107 U.S.

107 EURO

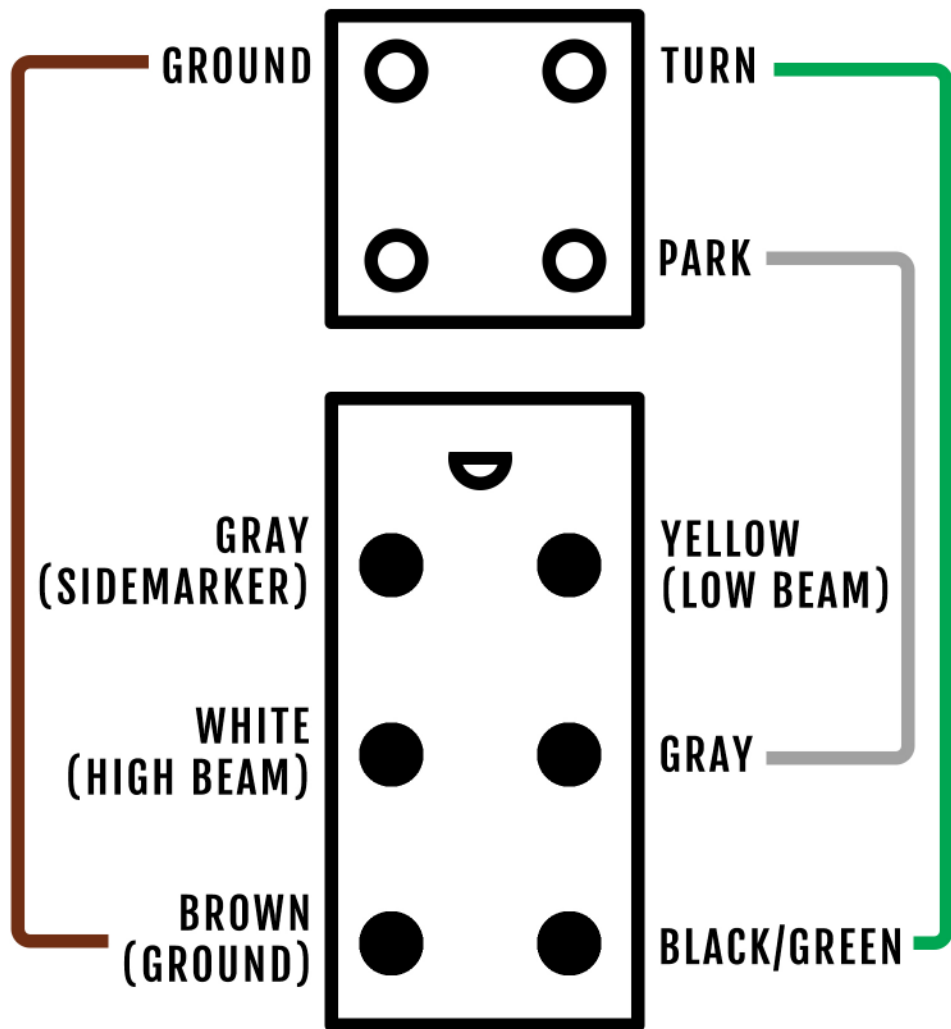
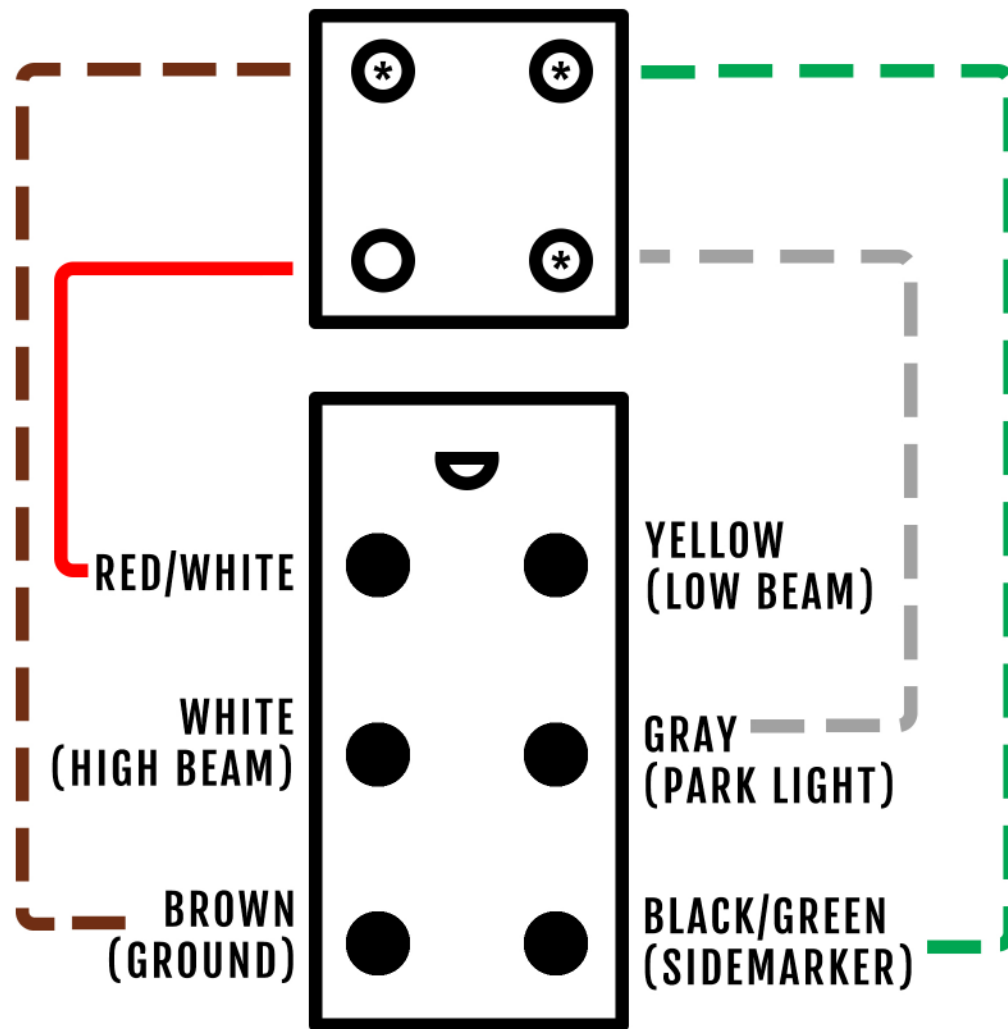
⊛ NEED TO ADD FEMALE PIN CONNECTORS

ADD GROUND & BOTH JUMPER WIRES AS SHOWN ABOVE BY DOTTED LINES TO MATCH U.S. PLUG-IN ON TURN SIGNALS. TAPE OFF OR REMOVE PLUG & WIRES TO HIGH BEAM ONLY SIDE OF THE FOUR-LIGHT HARNESS.
